# Optional Cable Resistance Measurement (CRM) - Part 2

GITESH BHAGWAT, ANDY GARDNER, HEATH STEWART  
SANTA BARBARA DESIGN CENTER

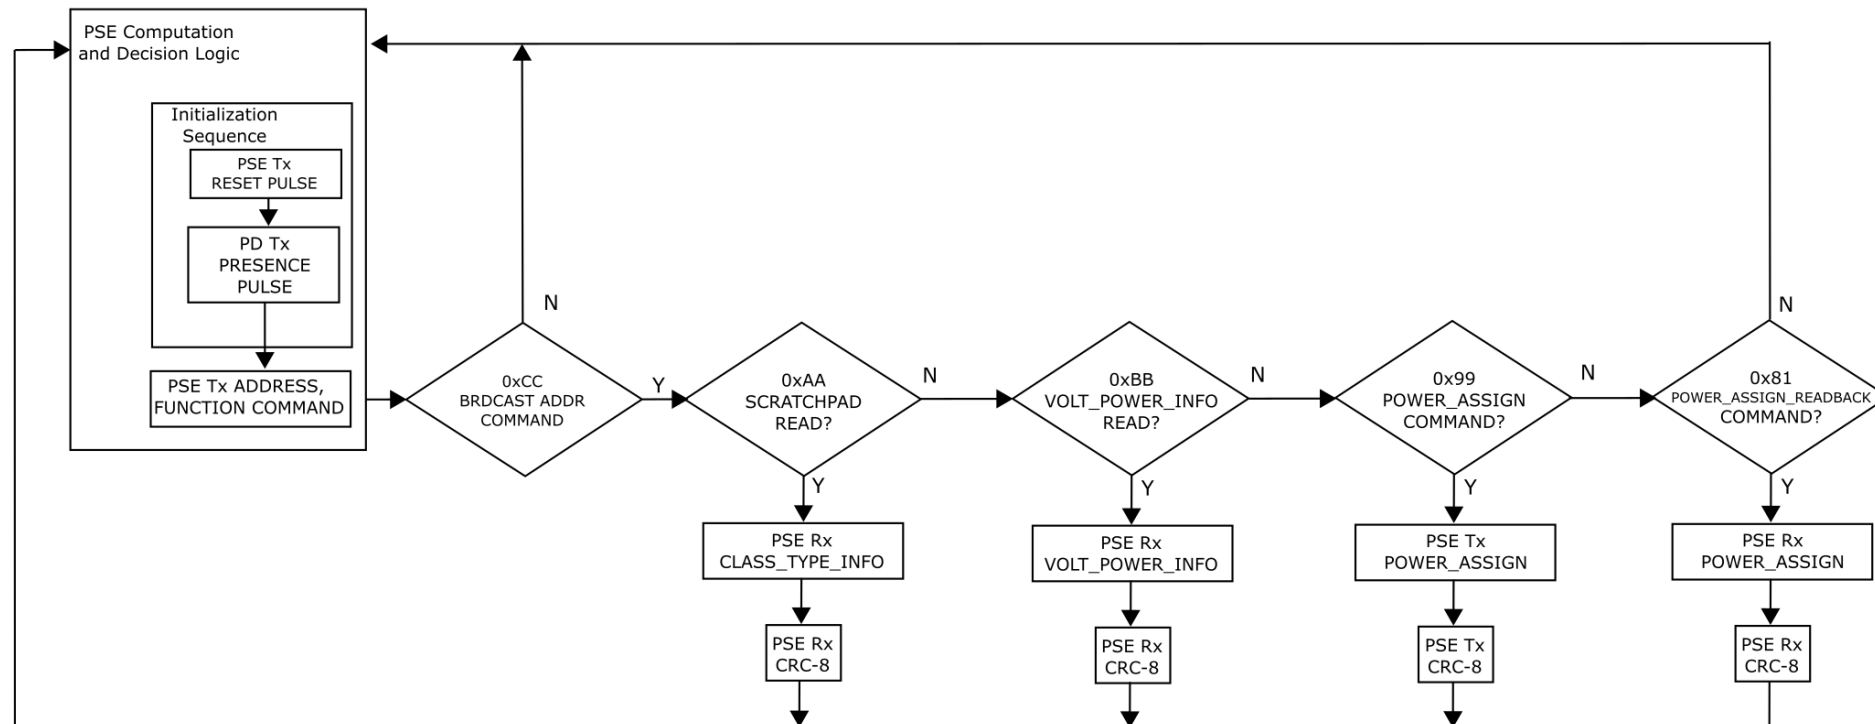
- ▶ Add One SCCP Command:
  - 0x81 : POWER\_ASSIGN\_READBACK
- ▶ Allows the PSE to ensure that assigned power was successfully received by PD
- ▶ Replace Figure 104-13 with the figure shown on this slide
